SERVICE BULLETIN

N° **139-616**

DATE: June 19, 2024

ATA 53 - LOWER LH TAIL LONGERON INSPECTION AND REPAIR

Figure 9

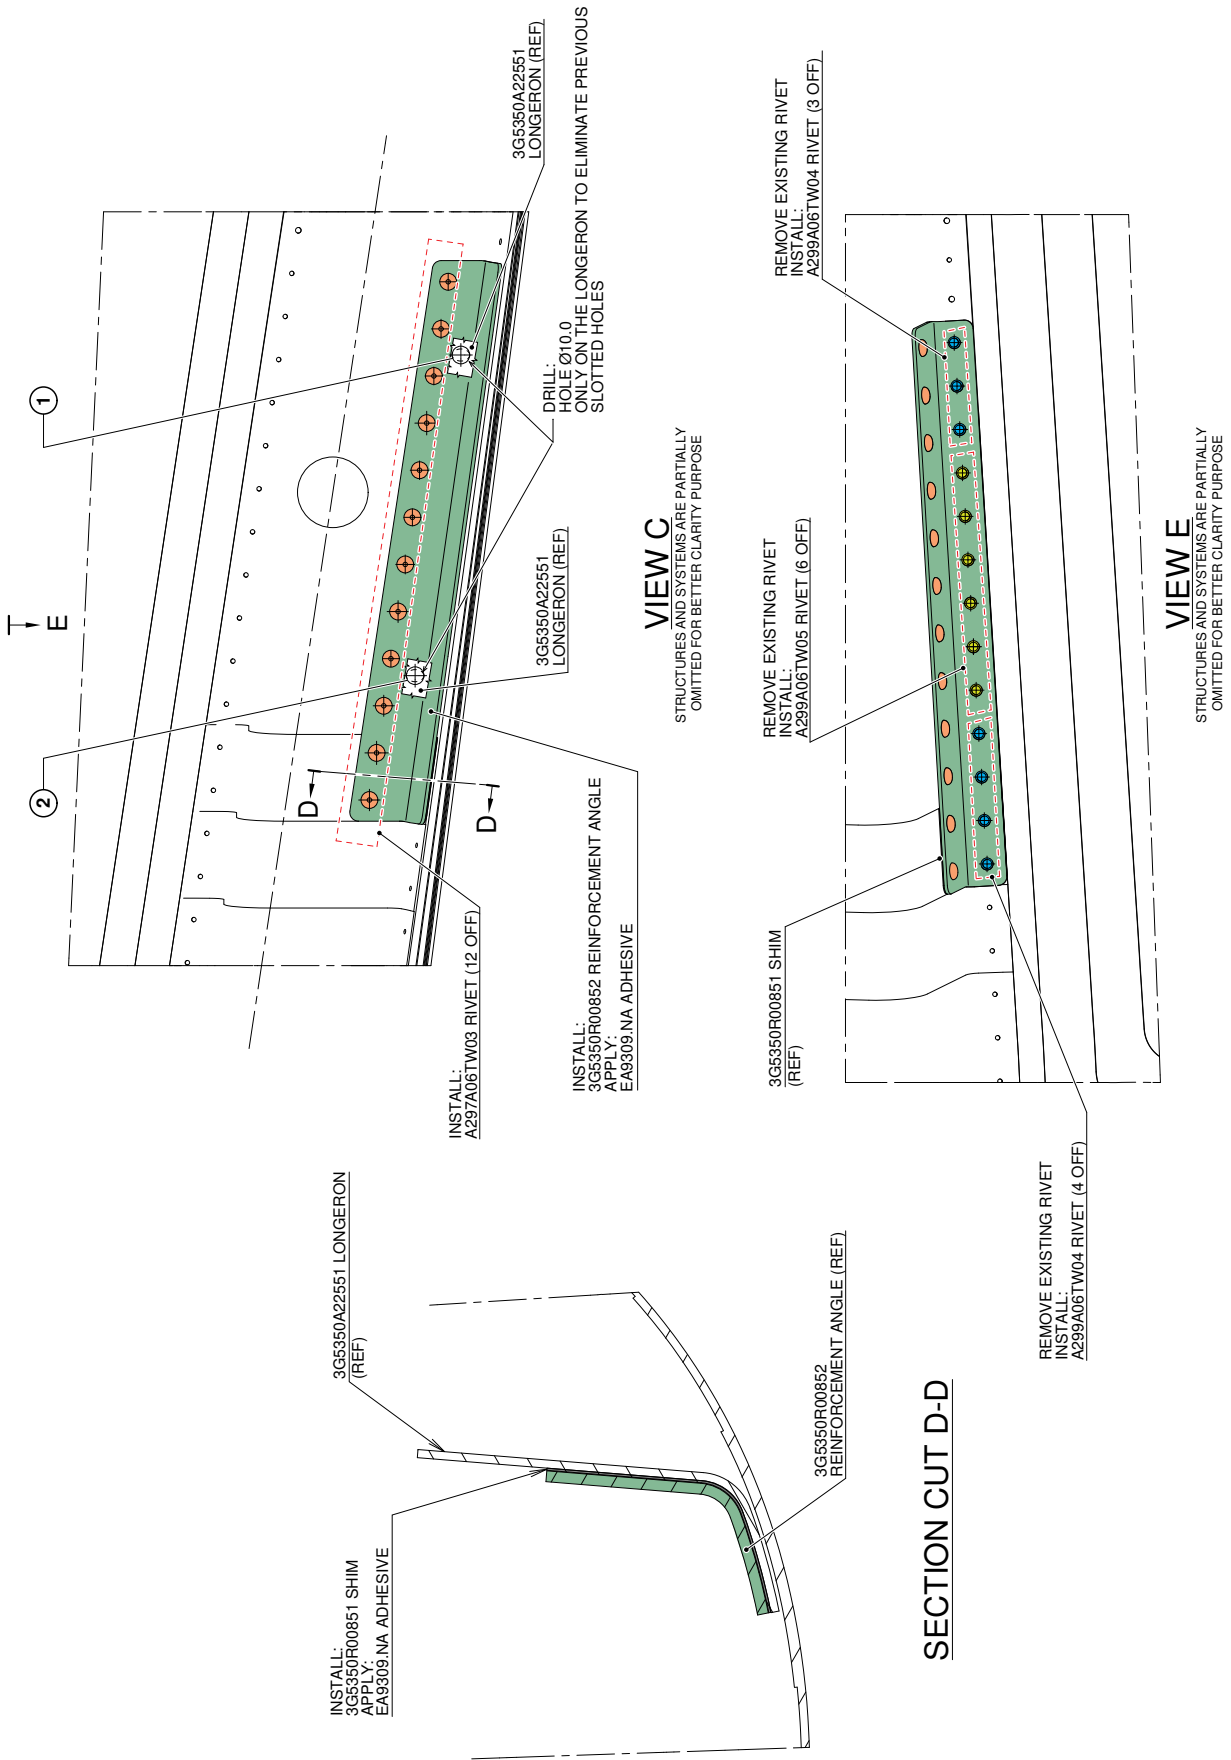
4. With reference to Figure 8 Detail A, drill out the indicated rivets.
5. With reference to Figure 8, in correspondence of previously removed rivet drill a hole \varnothing 3.25 normal to external profile on the longeron P/N 3G5350A22551 as indicated.
6. With reference to Figure 9 View C, from the internal side of the tail boom assy, widen the previously performed slotted hole up to \varnothing 10.0 only on the longeron.
7. With reference to Figure 8 Detail A, install rivet P/N AGS4720-508 on the doubler P/N 3G5350A20351.
8. With reference to Figure 9 View E, drill out the indicated existing rivets.

10. With reference to Figure 9 Section D-D, install shim angle P/N 3G5350R00851 by means of adhesive EA9309.3NA (C021) on the longeron P/N 3G5350A22551.

11. With reference to Figure 9, install reinforcement angle P/N 3G5350R00852 by means of adhesive EA9309.3NA (C021), n°12 rivets P/N A297A06TW03, n°7 rivets P/N A299A06TW04 and n°6 rivets P/N A299A06TW05.
12. Record the compliance with Part IV of this Service Bulletin on the component log card.

Figure 10

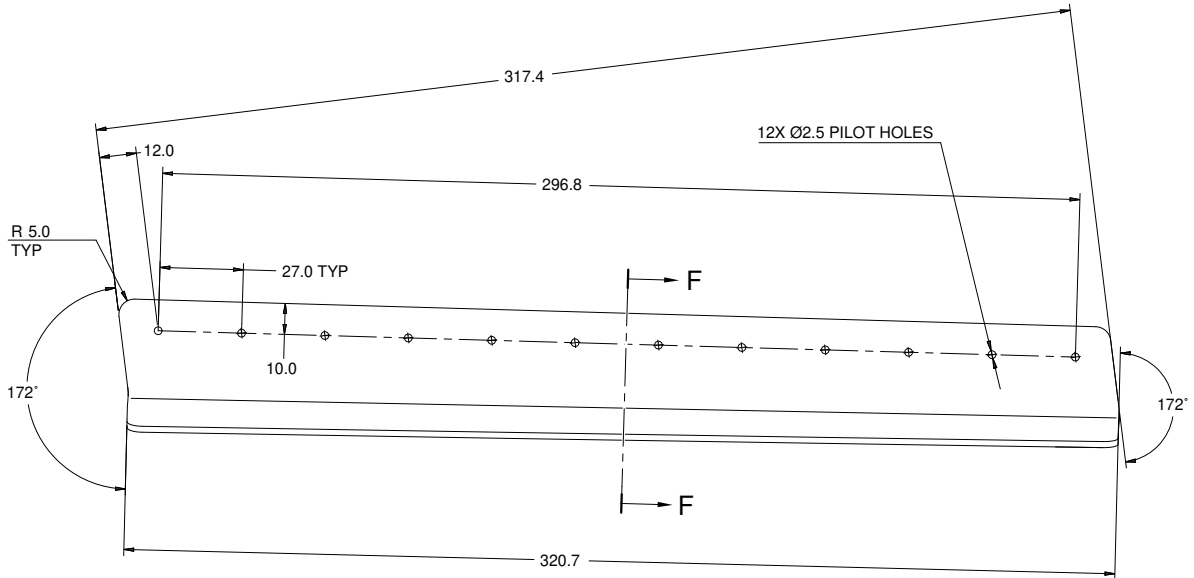
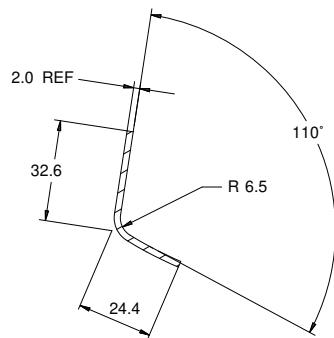
2. With reference to Figure 10, rework one plate AL-ALY 2024 (Thickness 2.00 mm) as indicated to obtain reinforcement angle and mark it as P/N 3G5350R00852.

Figure 11

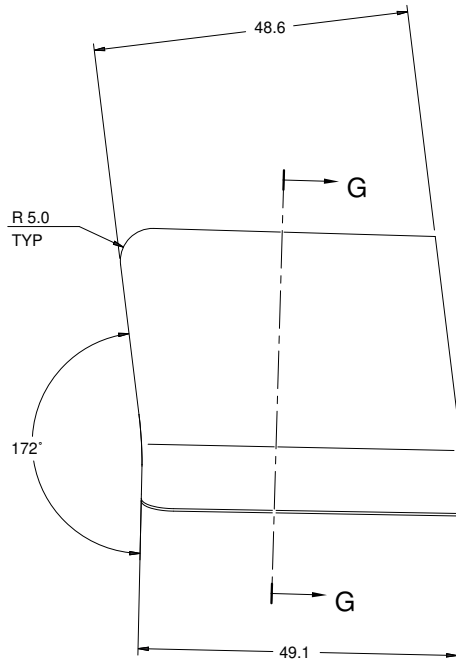
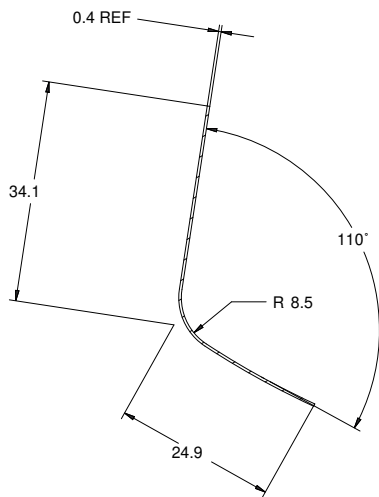
1. With reference to Figure 11, rework one plate AL-ALY 2024 (Thickness 0.40 mm) as indicated to obtain shim angle and mark it as P/N 3G5350R00851.

Figure 12

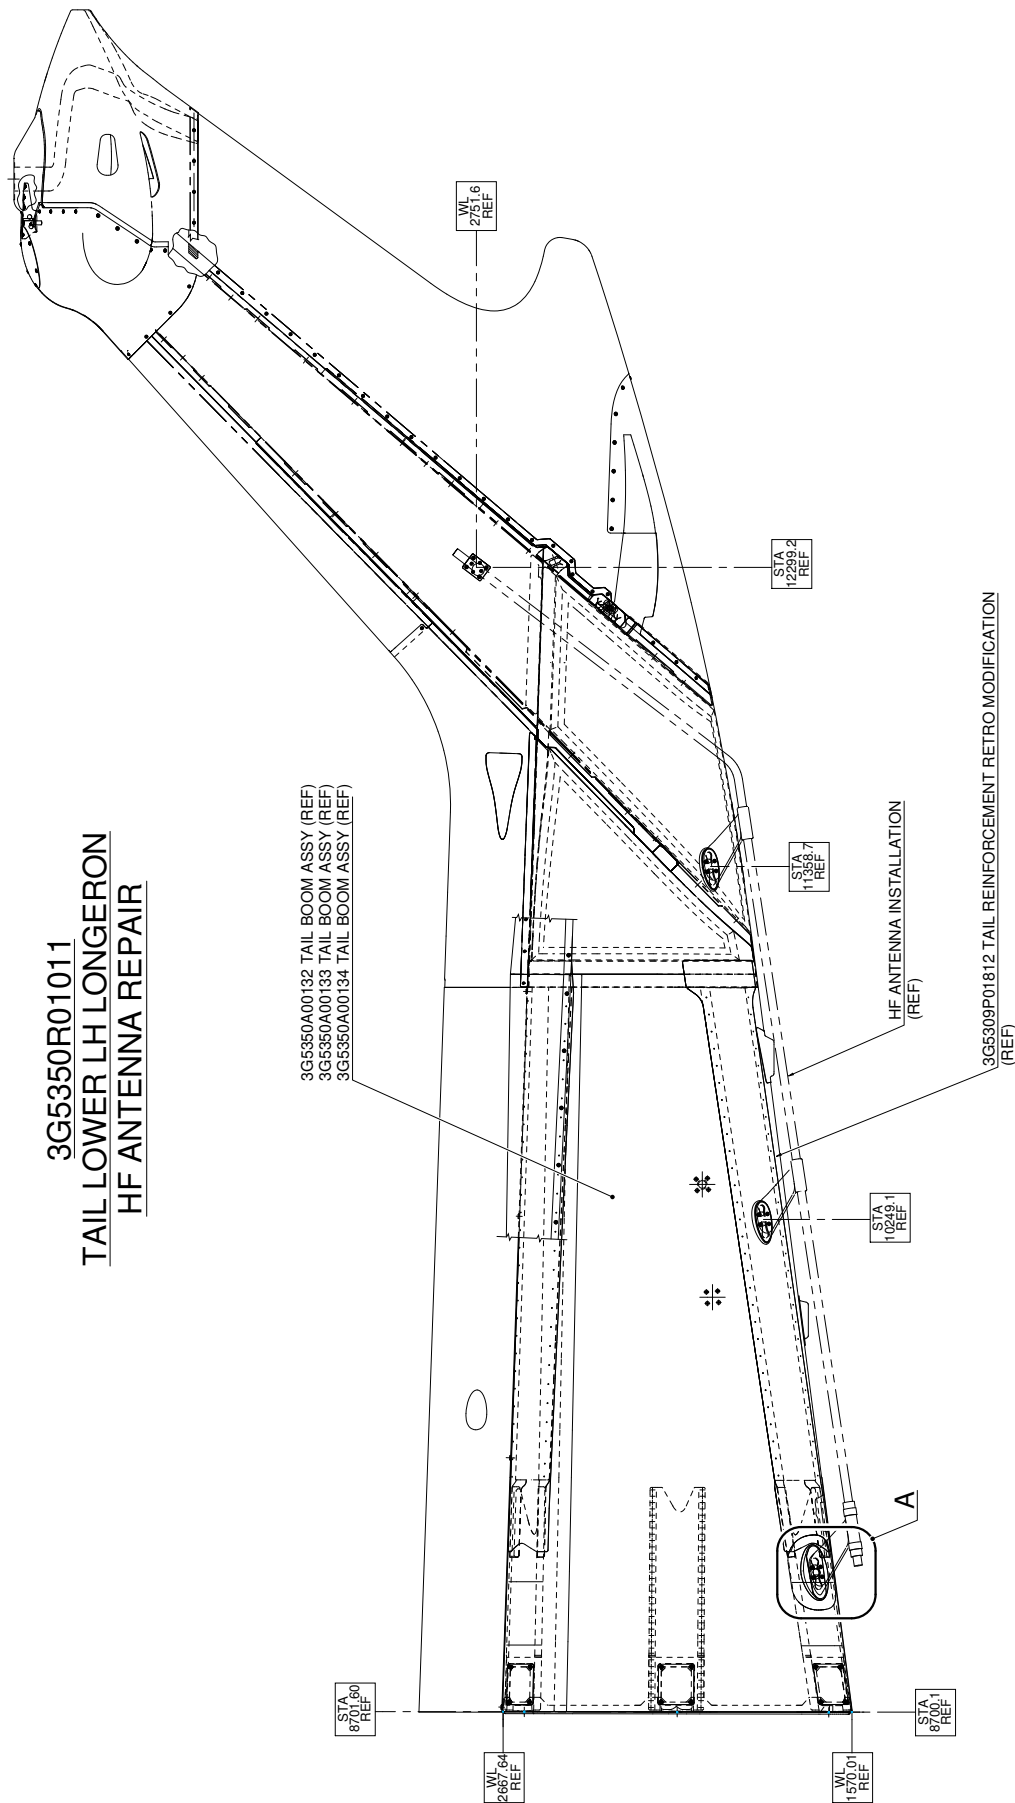
3. In accordance with AMP DM 39-A-06-41-00-00A-010A-A and with reference to Figure 12, remove all external panels, internal panels and internal liners as required to gain access to the area affected by the installation.

Figure 13

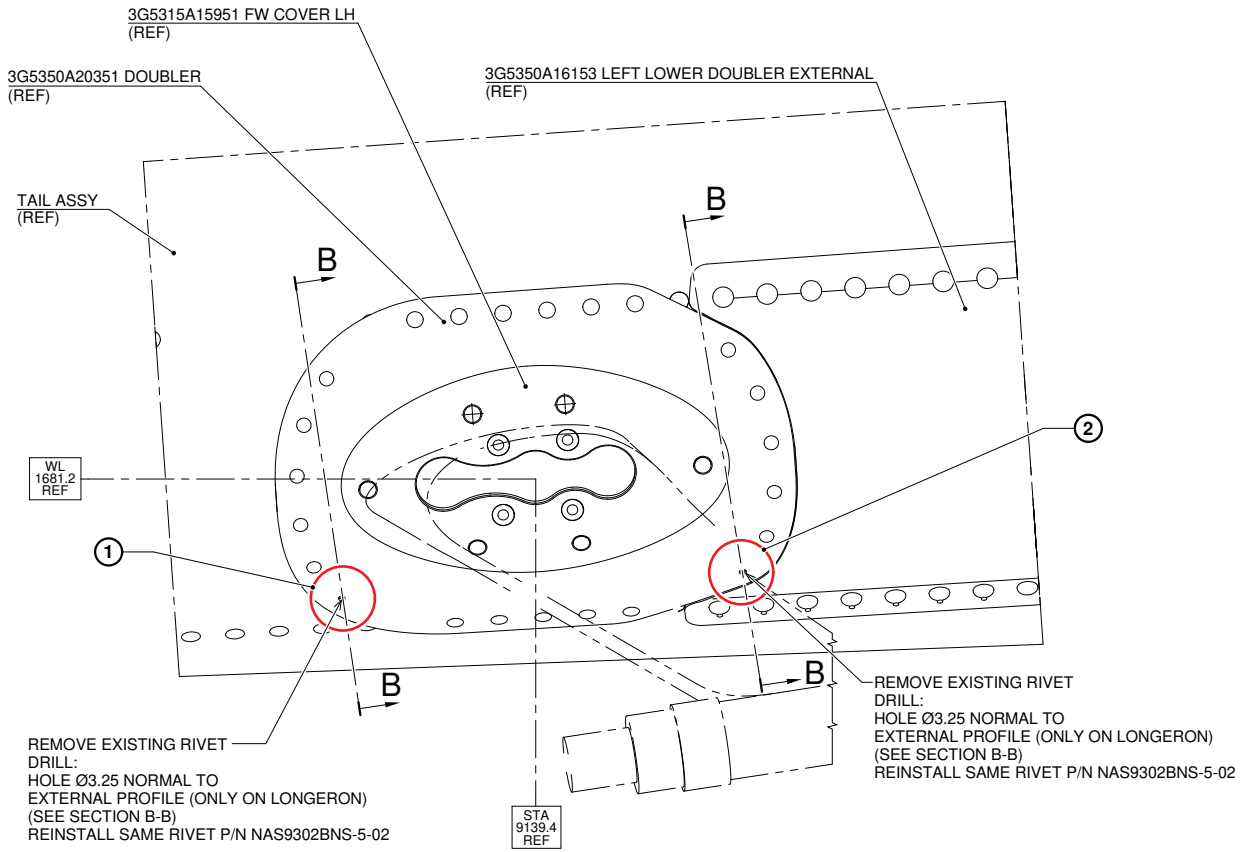
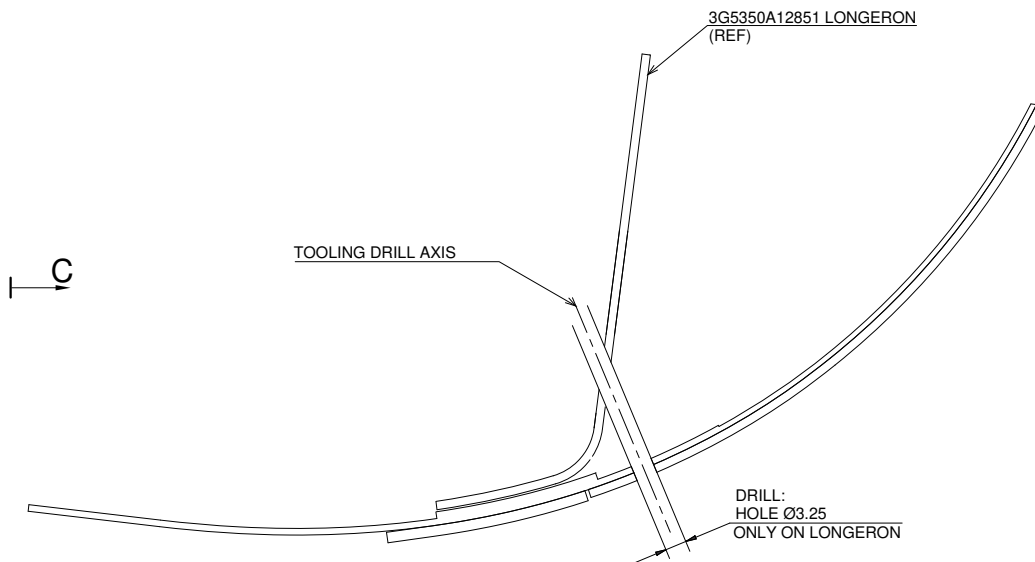
3. With reference to Figures 1 and 2 Detail A or Figures 7 and 8 Detail A or Figures 12 and 13 Detail A, perform a visual inspection to find drill marks on the internal side of the longeron in correspondence of the indicated rivets (location 1 and 2) as described in the following procedure:

- 3.1 With reference to Figure 2 Detail A or Figure 8 Detail A or Figure 13 Detail A, insert the boroscope inside the tail boom assy longeron passing through the hole on the FW cover LH or passing through the access panel 310BL.

4. With reference to Figure 13 Detail A, drill out the indicated rivet.
5. With reference to Figure 13, in correspondence of previously removed rivet drill a hole \varnothing 3.25 normal to external profile on the longeron P/N 3G5350A12851 as indicated.
6. With reference to Figure 14 View C, from the internal side of the tail boom assy, widen the previously performed slotted hole up to \varnothing 10.0 only on the longeron.
7. With reference to Figure 13 Detail A, install rivet P/N NAS9302BNS-5-02 on the doubler P/N 3G5350A20351.
8. With reference to Figure 14 View E, drill out the indicated existing rivets.

Figure 14

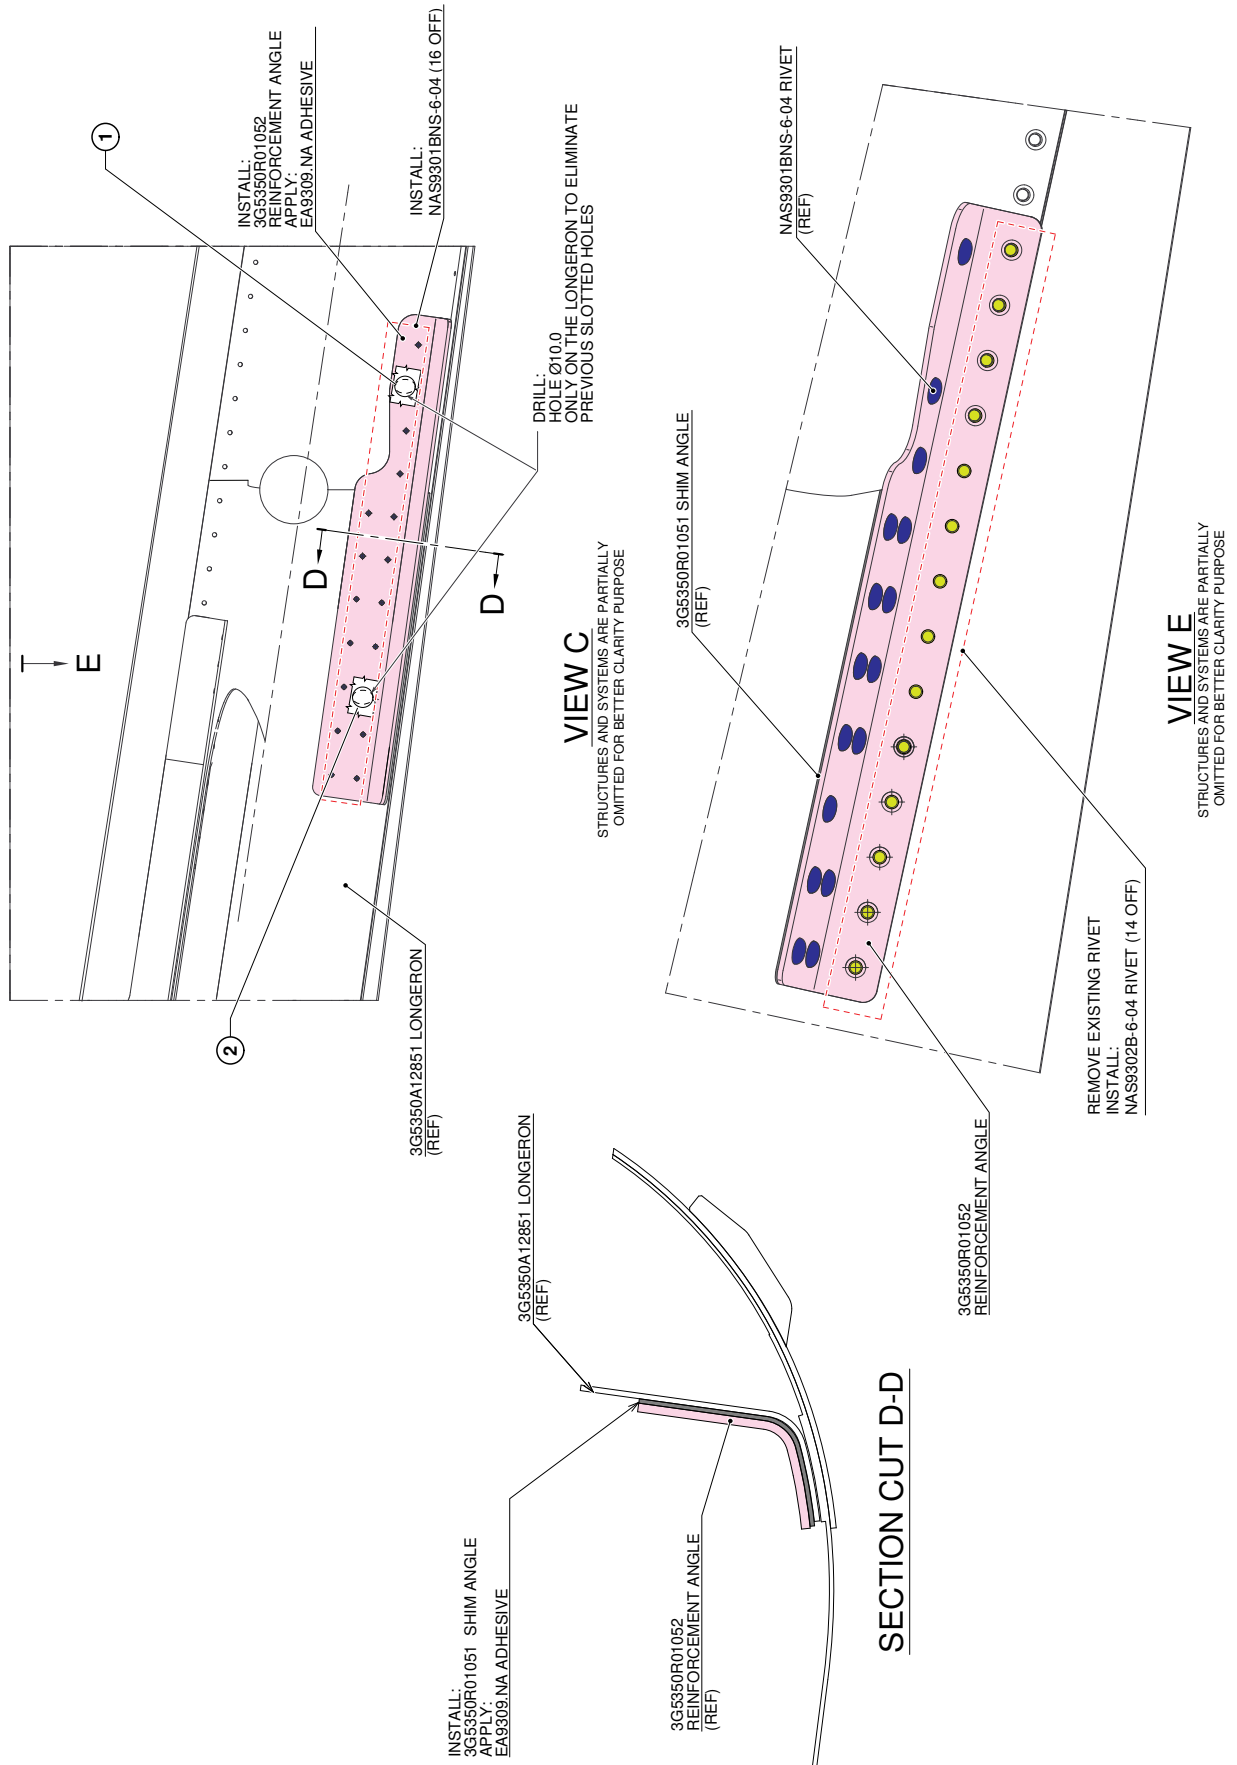
9. With reference to Figure 14 View E, temporarily locate the shim angle P/N 3G5350R01051 and the reinforcement angle P/N 3G5350R01052 and proceed as follows:
 - 9.1 Countermark on the shim angle the positions of existing rivets previously removed at step 8 and the positions of existing holes of the reinforcement angle.
 - 9.2 Countermark on the reinforcement angle the positions of existing rivets previously removed at step 8.
 - 9.3 Countermark on the longeron the positions of existing holes of the reinforcement angle.
 - 9.4 Drill pilot holes Ø2.50 through the shim angle, the reinforcement angle and the longeron in the previously countermarked positions.

10. With reference to Figure 14 Section D-D, install shim angle P/N 3G5350R01051 by means of adhesive EA9309.3NA (C021) on the longeron P/N 3G5350A12851.

11. With reference to Figure 14, install reinforcement angle P/N 3G5350R01052 by means of adhesive EA9309.3NA (C021), n°14 rivets P/N NAS9302B-6-04 and n°16 rivets P/N NAS9301BNS-6-04.
12. Record the compliance with Part III of this Service Bulletin on the component log card.

Figure 15

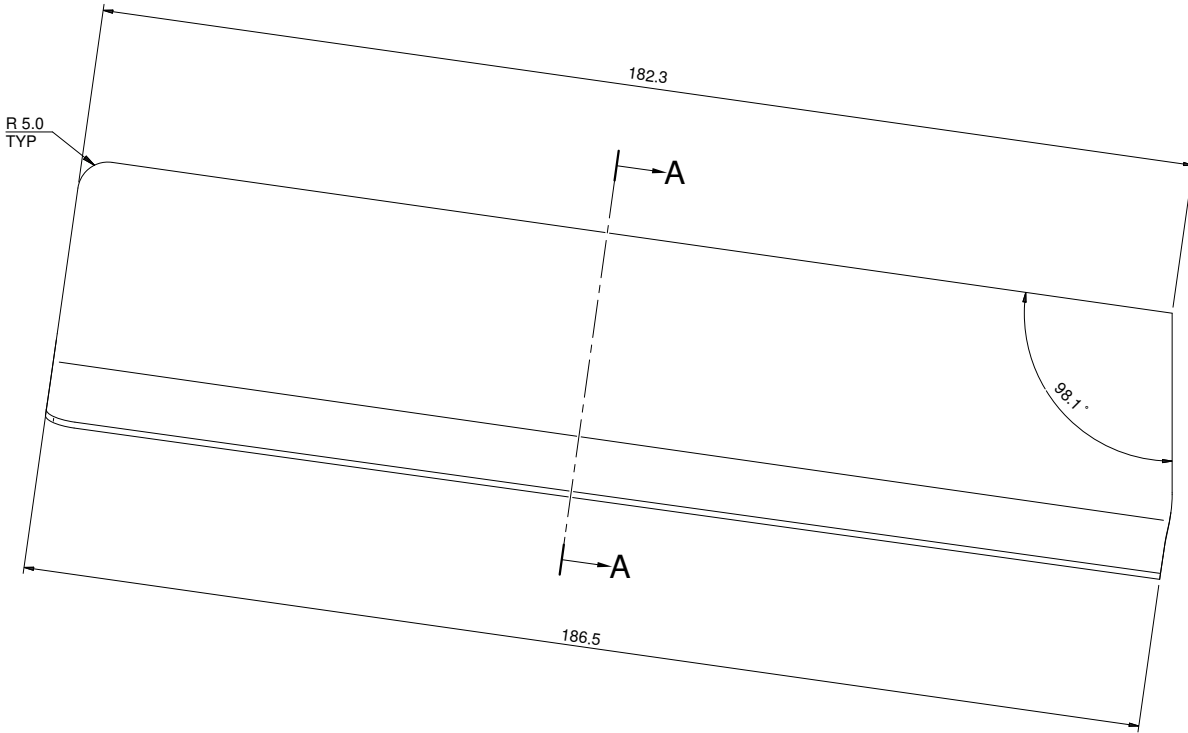
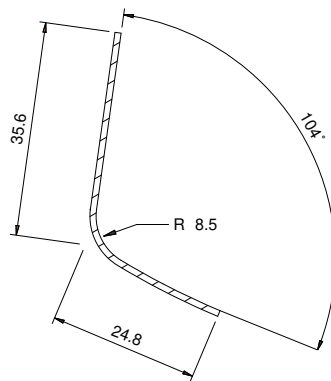
1. With reference to Figure 15, rework one plate AL-ALY 2024 (Thickness 1.02 mm) as indicated to obtain shim angle and mark it as P/N 3G5350R01051.
